PLANNING COMMISSION MEETING
Monday, May 28, 2026 – 7:00 p.m.
Farmington City Hall
Council Chambers
23600 Liberty Street
Farmington, MI 48335

**Farmington Planning Commission
Staff Report**

Subject: Vibe Credit Union (Special Land Use Review)
Location: 31806 Grand River Ave (parcel ID: 23-27-403-141)
Zoning: C2 Community Commercial
Plan Date: April 24, 2026
Applicant: Hunter Karam

Subject: Vibe Credit Union (Site Plan Review)
Location: 31806 Grand River Ave (parcel ID: 23-27-403-141)
Zoning: C2 Community Commercial
Plan Date: April 24, 2026
Applicant: Hunter Karam

L1

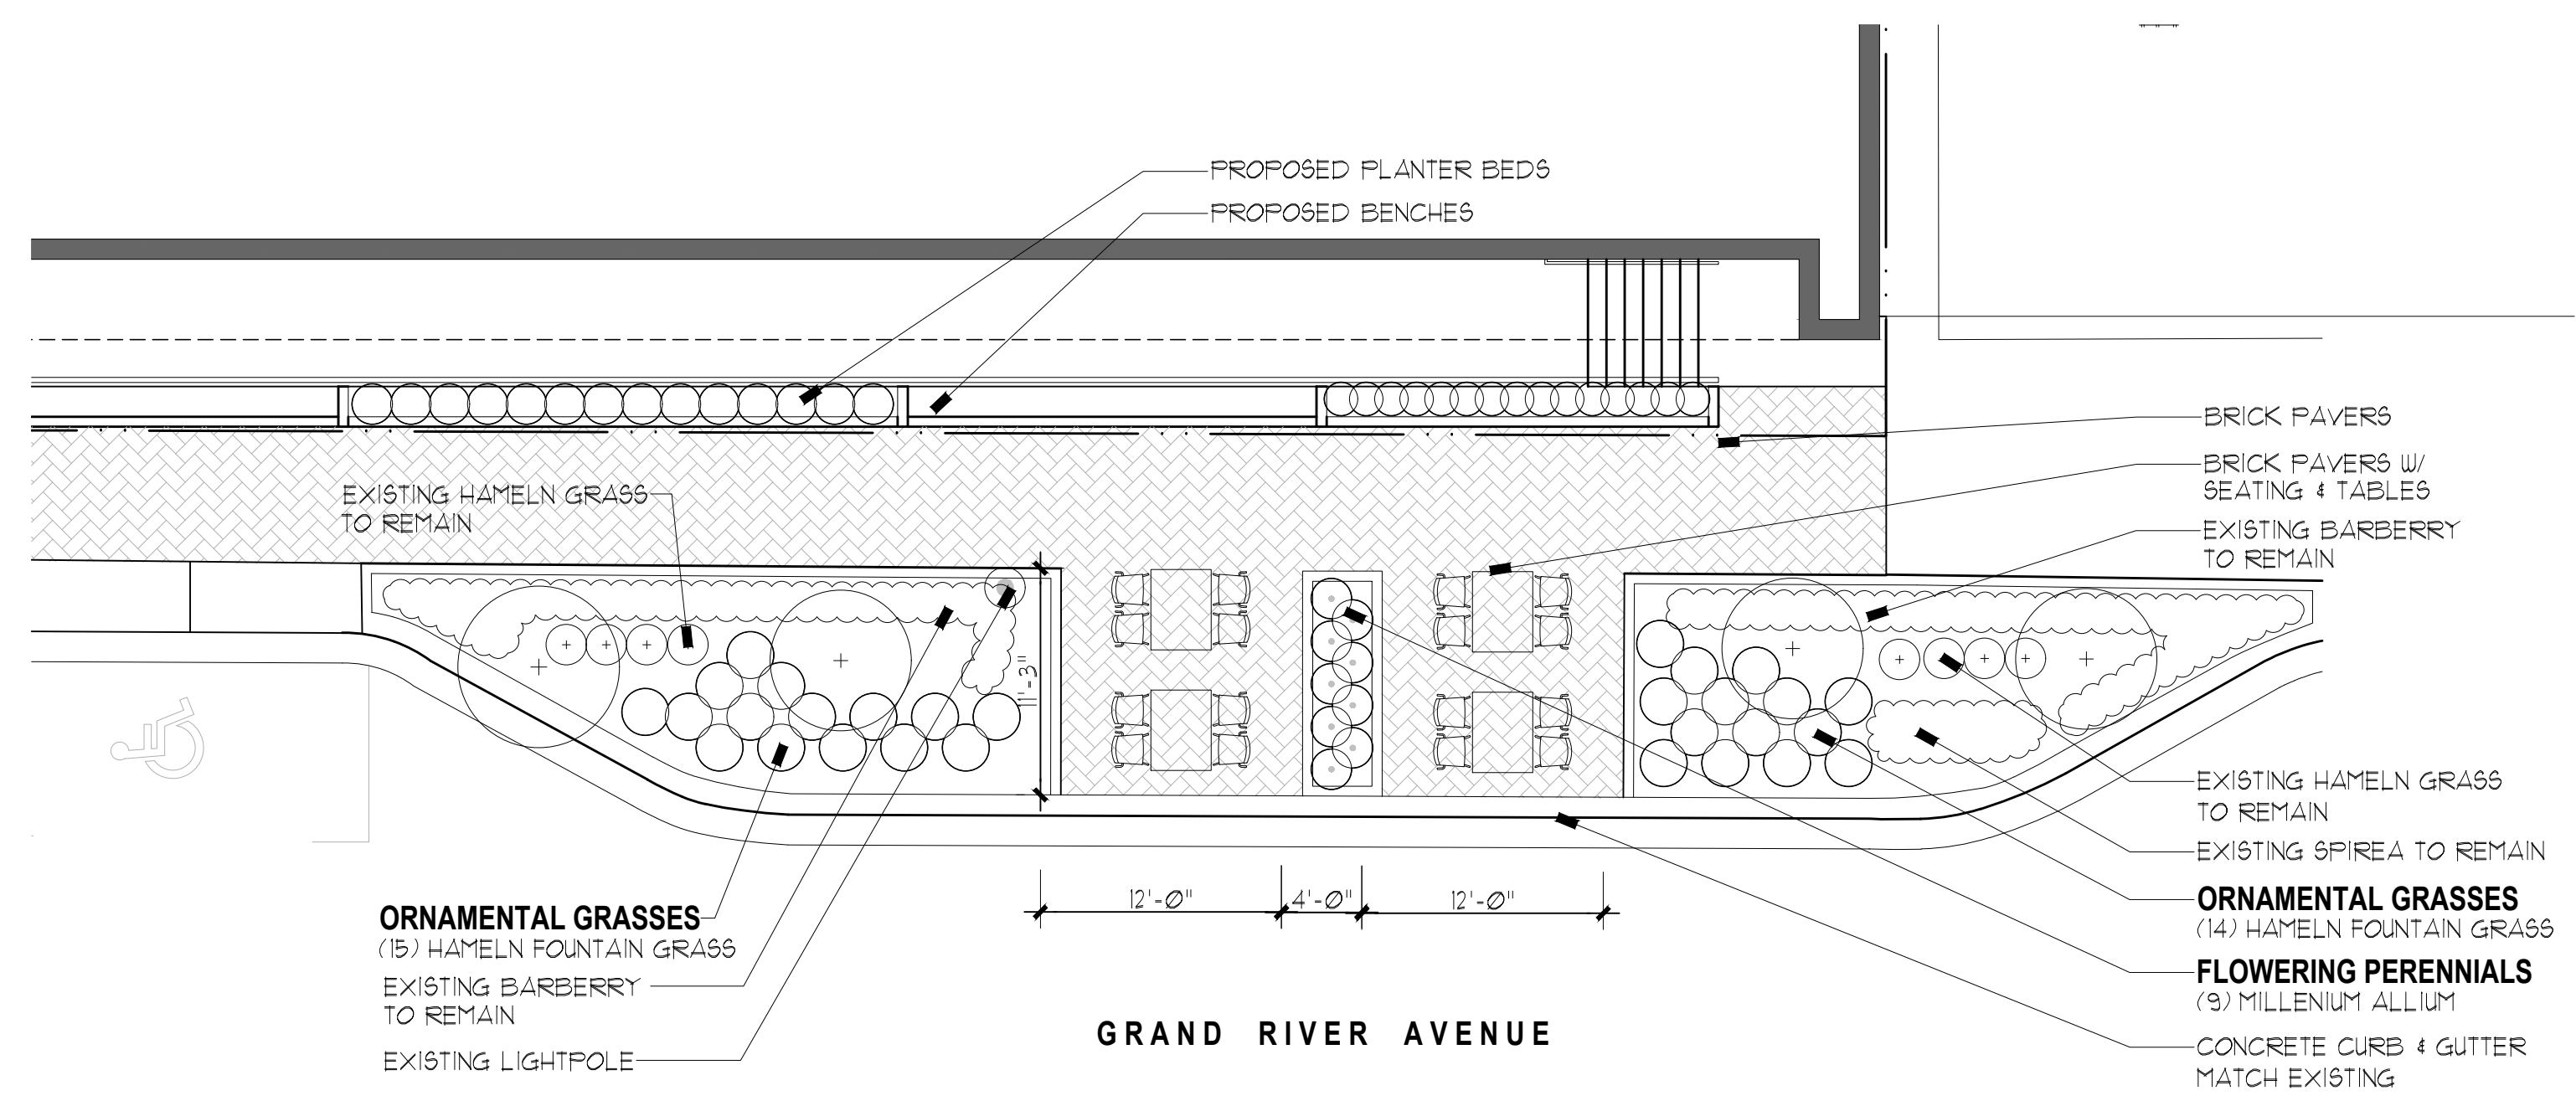
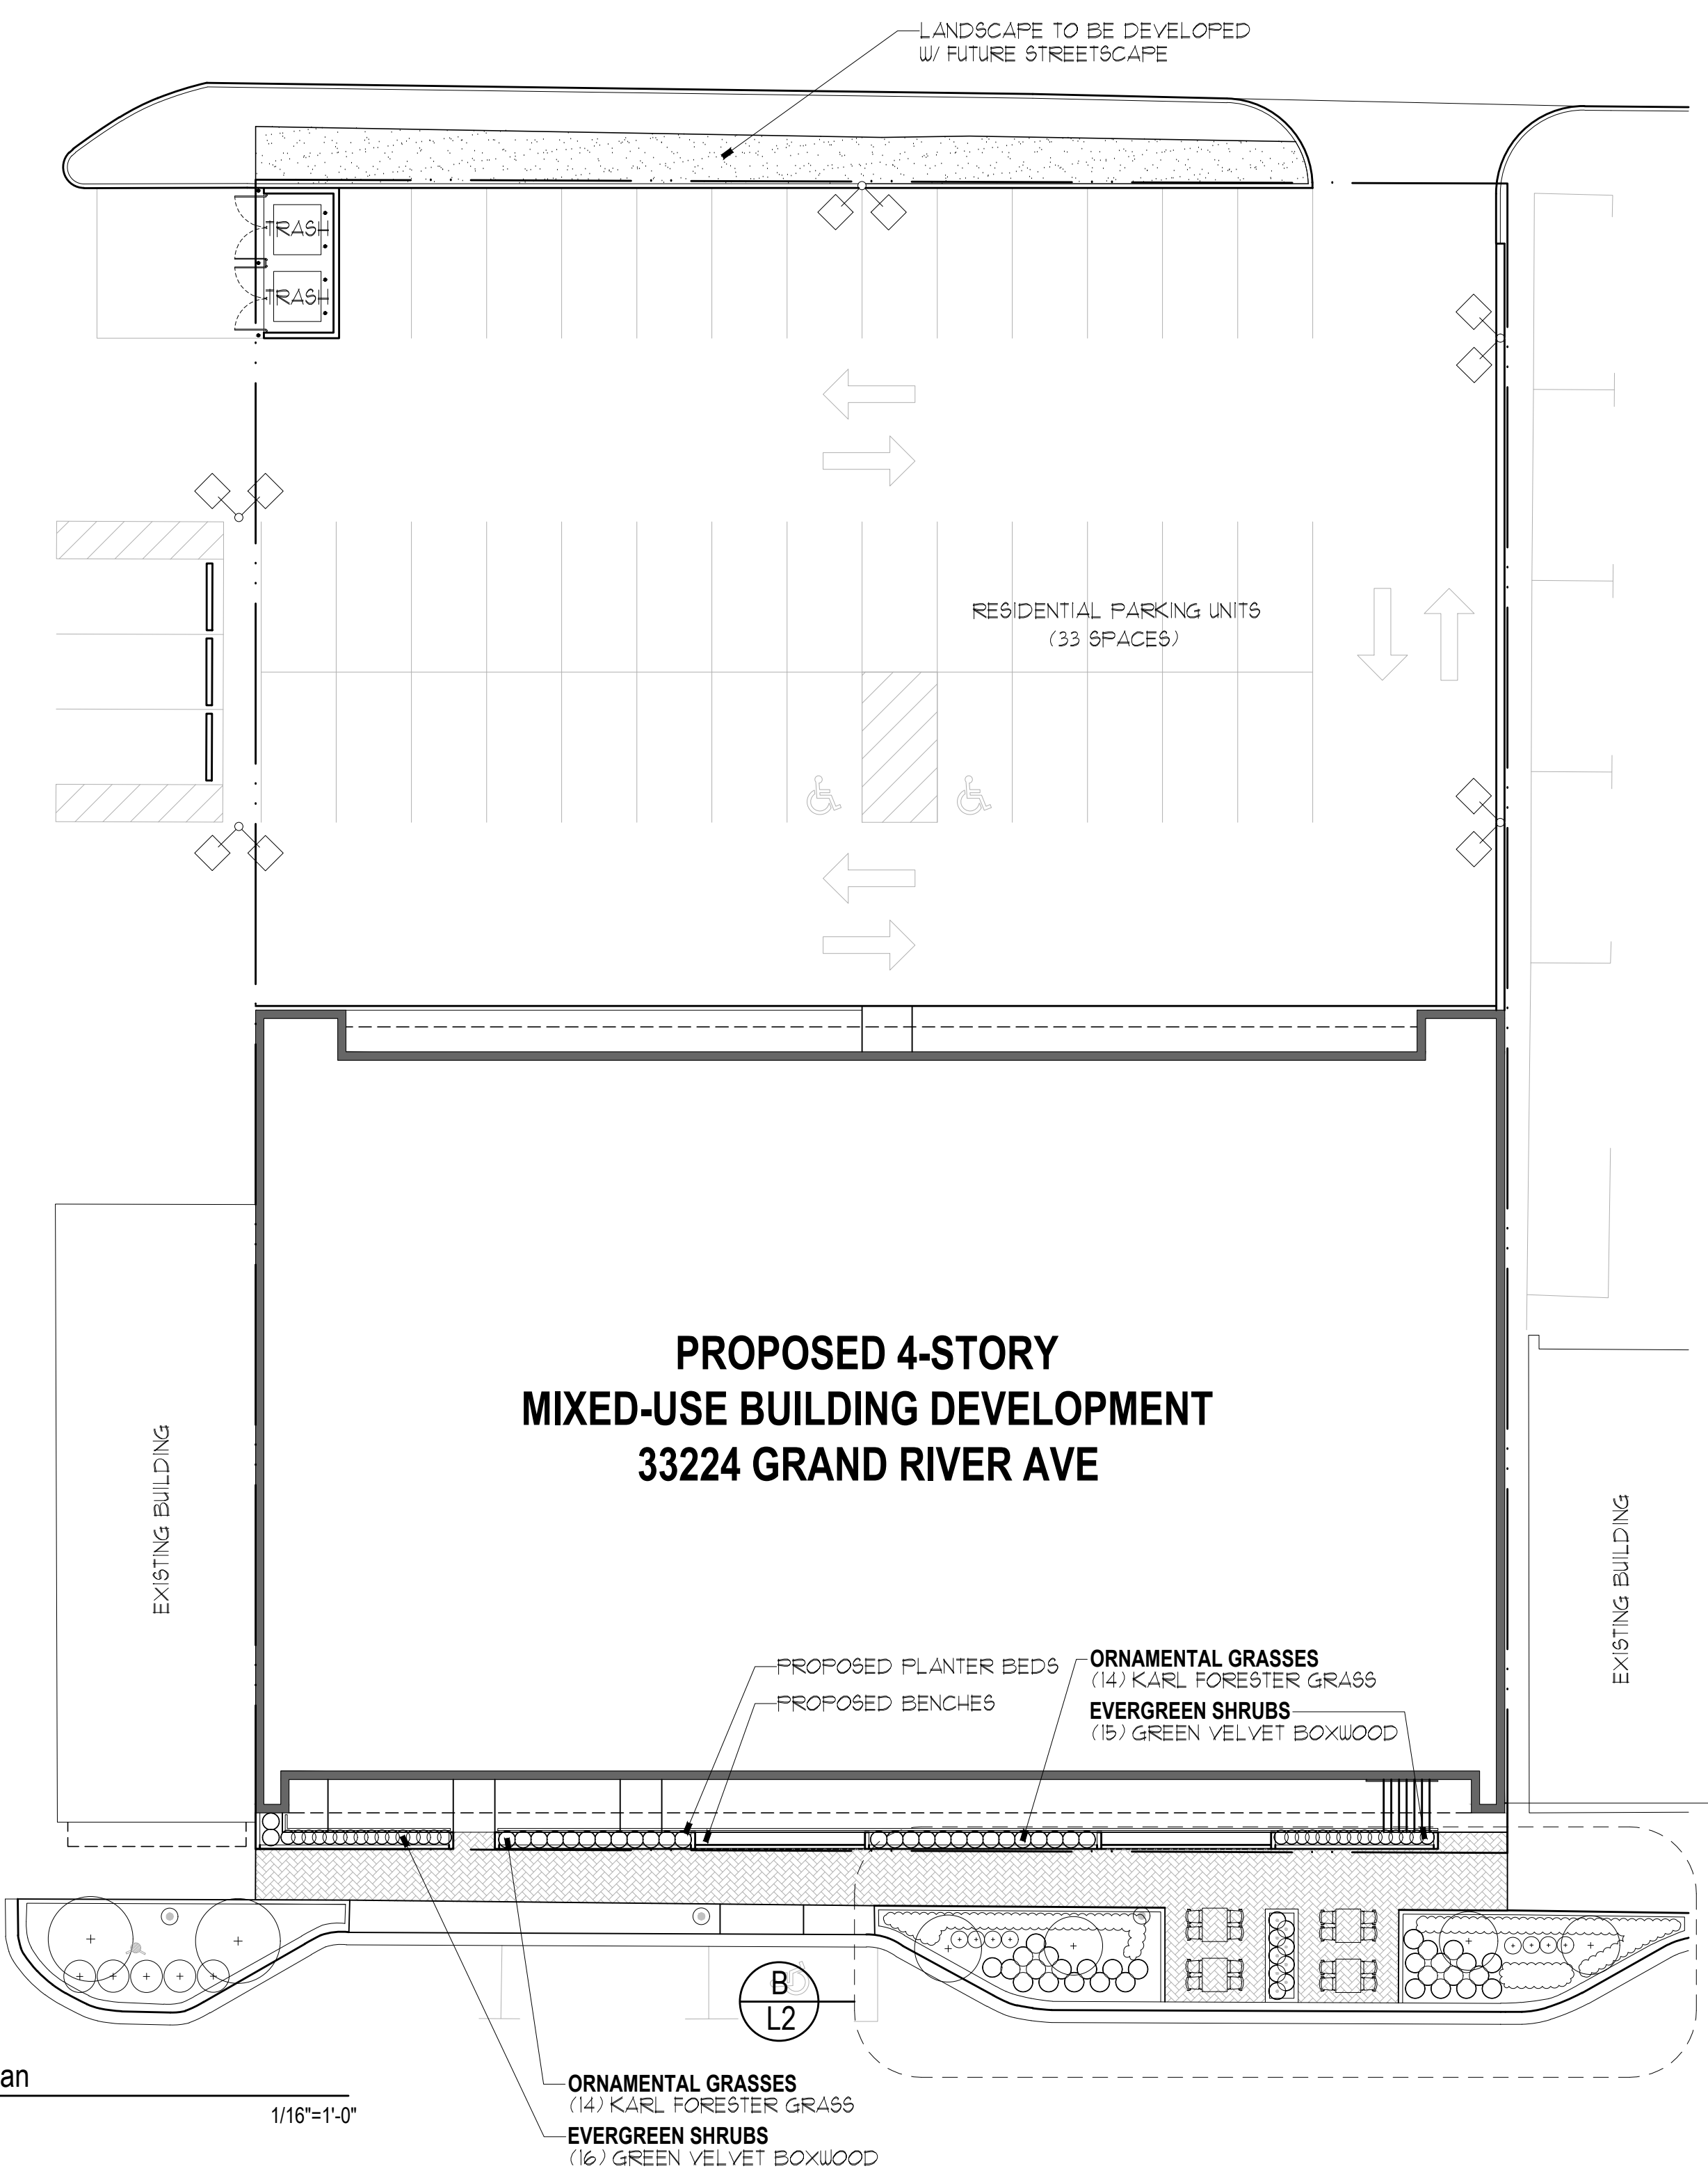
- 13. Installation, Irrigation and Maintenance (§35-184).** All landscaped areas shall be provided with an underground irrigation system. On Sheet L1 the applicant indicated that a new irrigation system will be
